## Kenai Peninsula Borough

# Meeting Agenda Plat Committee

Monday, August 8, 2022

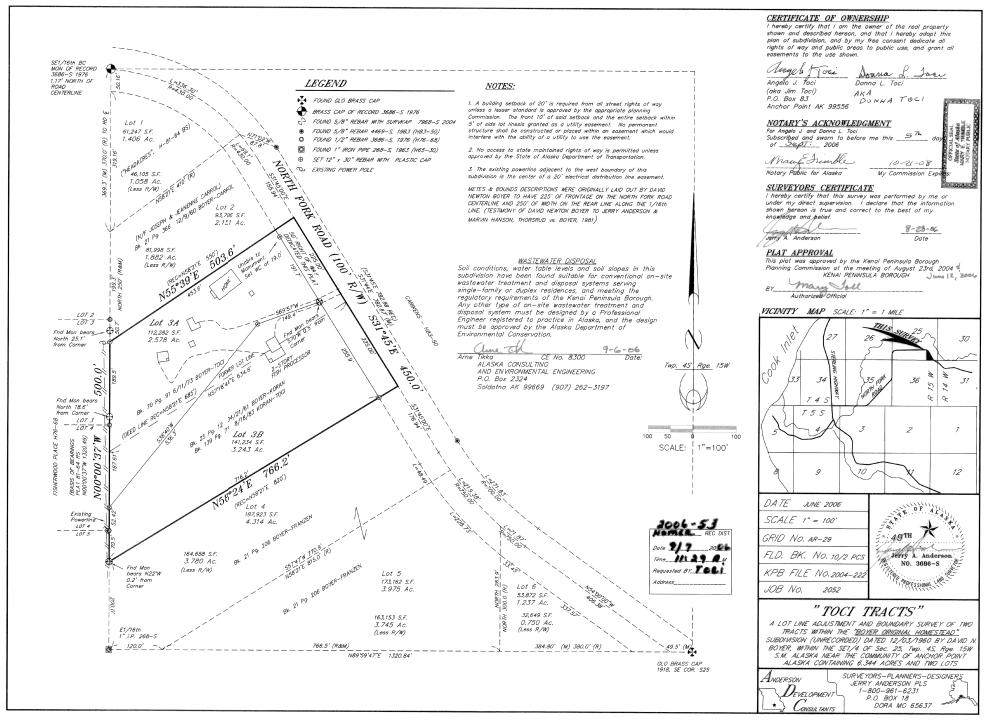
There appears to be a joint drive usage with Lot 3A to the North of Lot 4B. If this is going to be a continuing use, a drive easement needs to be depicted, filed and shown on the Final Plat. If not, a note needs added to the Final stating new access is being acquired from the State of Alaska.

Othicy provide	Stiffly provider review.		
HEA	Locate the overhead electric line and depict on the final plat. Provide a plat note that states,		
	"The existing overhead powerline is the centerline of a 30-foot-wide electrical easement,		
	including guys and anchors, granted this plat."		
ENSTAR	No objection		
ACS	No objection		
GCI	No objection

- **Staff recommendation:** To the west, Lot 6 is 6A and 7 is 7A in subdivision HM87-19, please change accordingly.
- H. Approximate locations of low wet areas, areas subject to inundation, areas subject to flooding or storm water overflow, and the line of ordinary high water. This information may be provided on an additional sheet if showing these areas causes the preliminary plat to appear cluttered and/or difficult to read;
  Staff recommendation: There is a lake on the lot to the South depicted as BK 21 PG 206 HRD.

**Staff recommendation**: show basis of bearing.

Staff recommendation: Add a legend to the drawing

**Staff recommendation**: Show monumentation of found and set pins

Fritz Creek Acres 2022 Replat; KPB File 2022-095 Seabright Surveying / Gamble, Sealevel Inc. Location: Mushroom Street & East End Road Fritz Creek Area / Kachemak Bay APC

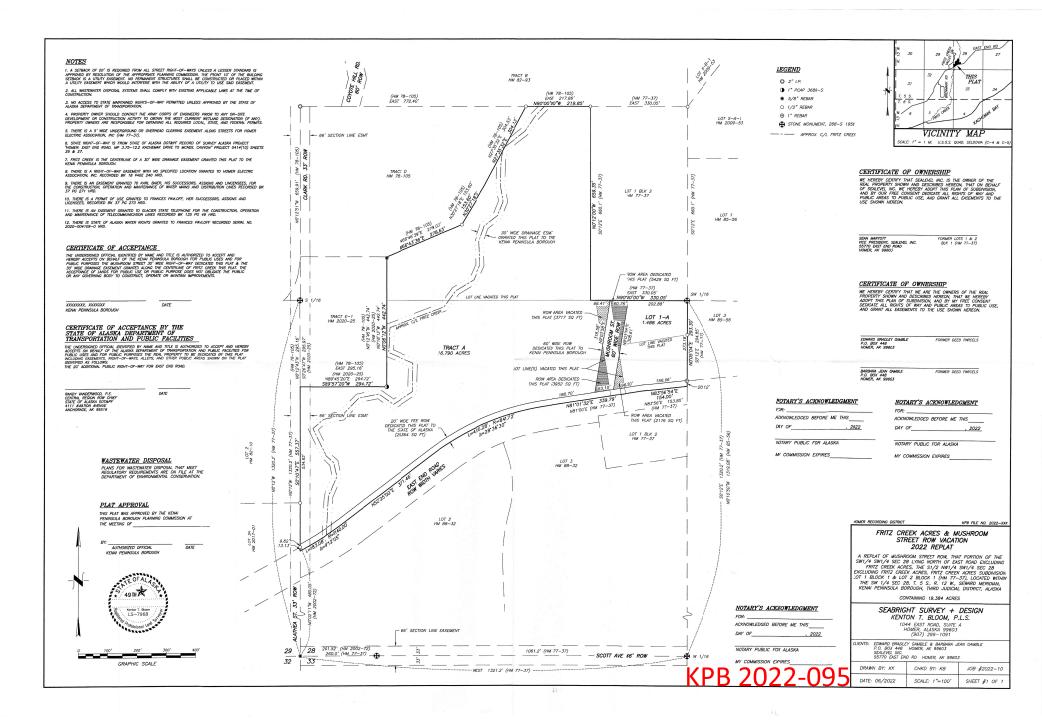
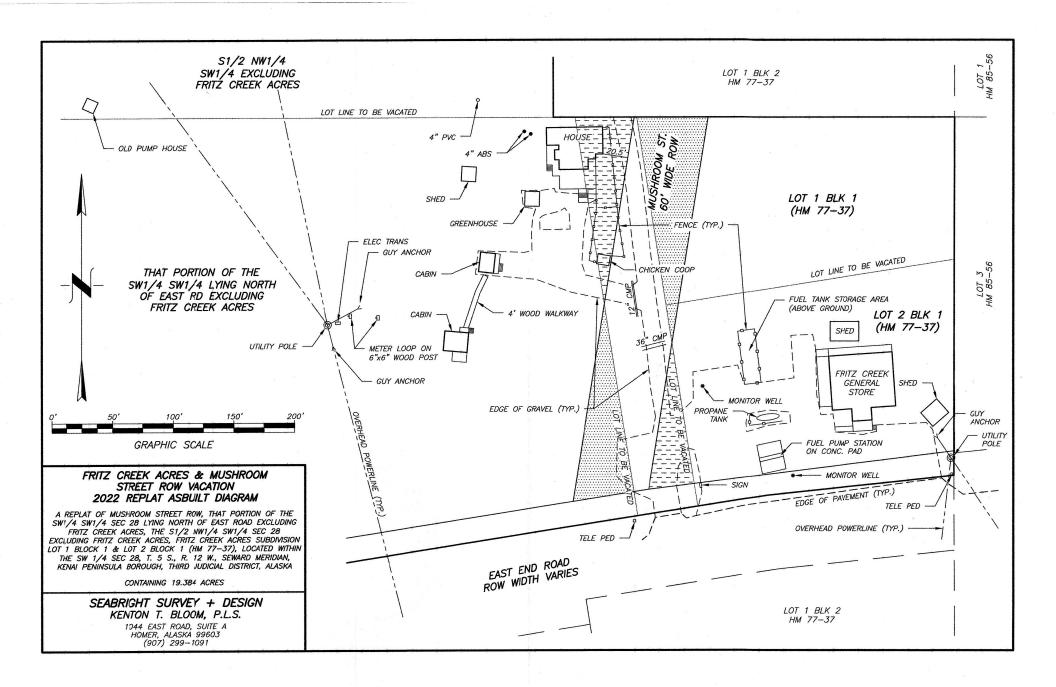
The access to the three lots currently using Mushroom Street after the new dedication looks to be outside the dedication. The surveyor needs to show how access will be finalized after. If a new road is being proposed, plans need to be submitted to the Roads Department for approval.

Easement in Book 135 Page 49 granted to Glacier State Telephone, for telephone, telegraph and communication lines and appurtenances. Document states it will attach to the existing HEA pole line crossing the property with a diagram given. **STAFF RECOMMENDS:** Surveyor confirm existence of overhead lines and appurtenances and show on Final with notes to identify the easements related to the lines.

Add to notes concerning 10' Utility Easement along all Street Right-of-ways inside the 20' setback.

Bearings and distances along the drainage easement being granted need to be added for the Final.

**Staff recommendation:** Legal should more resemble the Certificate to Plat description to include more of the exceptions to the land, please revise for Final. May want to consider moving 2022 Replat to behind Fritz Creek Acres to reduce confusion of the name.

- **Staff recommendation:** Verify that new dedication of Mushroom Street will accommodate the access to Tract C. Otherwise show new access road location.

- **Staff recommendation:** Road names labeled northwest of the subdivision were changed, they should be changed to Fritz Creek Valley Drive.
- J. Block and lot numbering per KPB 20.60.140, approximate dimensions and total numbers of proposed lots; **Staff recommendation:** Need dimensions added on the 20' fee dedication along East End Road, inside Tract A.

- N. Apparent encroachments, with a statement indicating how the encroachments will be resolved prior to final plat approval;
  - **Staff recommendation:** Plat will be fixing the encroachment into the right-of-way. Reviewing detail drawing shows house to be outside setback, but using a scale shows different, surveyor should confirm results. Existing fence looks to be to still be encroaching on new Mushroom Street right-of-way and will need to be moved inside property line.

**Staff recommendation**: comply with 20.60.110. Add dimensions to the line on the backside of the road dedication.

KPB File Number 2022-104 7/14/2022

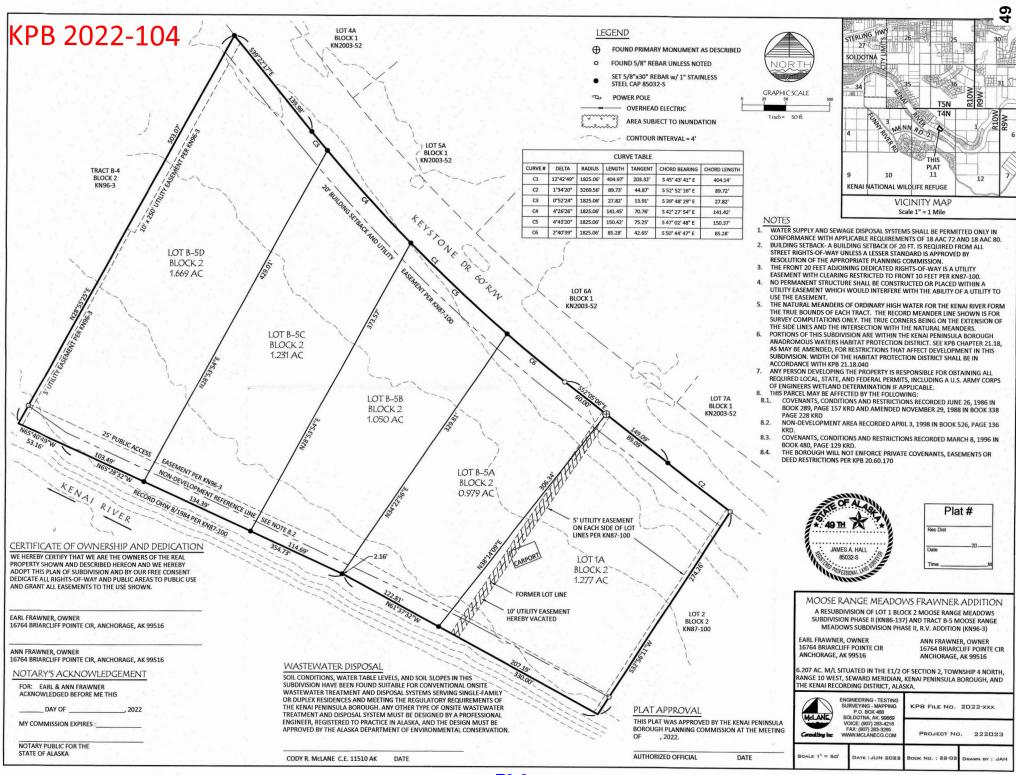
<u>Site Investigation:</u> There are several structures and an existing driveway accessing Keystone Drive located on Lot 1A. The carport is located within the Utility Easement on the West side of the lot, that will be vacated at the Planning Commission meeting on August 8, 2022.

Per KPB GIS, the steep slopes falling to the river lie within the platted lines at the back side of the lots. Surveyor should verify their location and if in the lots, show the top of the back on the Final Plat. The property sheet drains towards the Kenai River.

**Staff recommendation:** Change parent subdivision name to Moose Rane Meadows Subdivision Phase II Amended Plat (KN 87-100)

Staff recommendation: Remove Block 1 from the lots across the street to the East

Warfle Tracts #3 Tract A-3

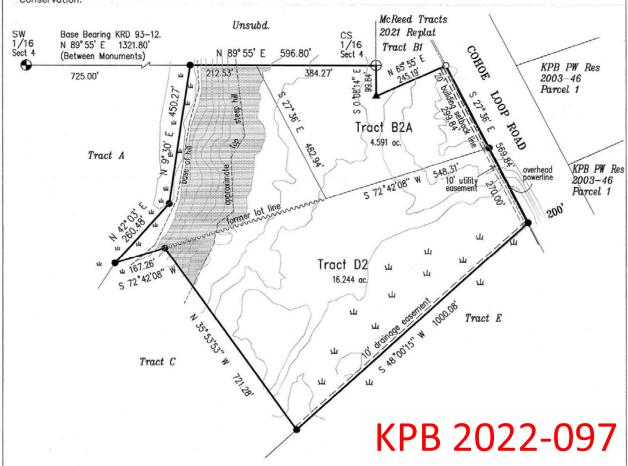
<u>Site Investigation:</u> The property has steep sloops located on it. The area with slopes greater than 20 percent is shaded on the plat. A portion on the East side of the property contains a swamp area as indicated on the plat. **Staff recommends** the shading be removed from the final, but correctly show the top of sloop. Leave the swamp area and place a note on the final plat indicating any person developing the property is responsible for obtaining all required local, state, and federal permits, including a U.S. Army Corps of Engineers wetland determination if applicable.

other provider review.	
HEA	Show 15' easement centered on existing underground line crossing property
ENSTAR	No objection
ACS	No objection
GCI	Approved as shown

**Staff recommendation:** Correct name of McReed Tracts to McReed Subd. In original name, in title and on drawing.

Need to add correct subdivision labeling around parcels.

Staff recommendation: At request of ADOT, show internal circulation on plat.

Staff recommendation: Need to add surveyor's certificate.
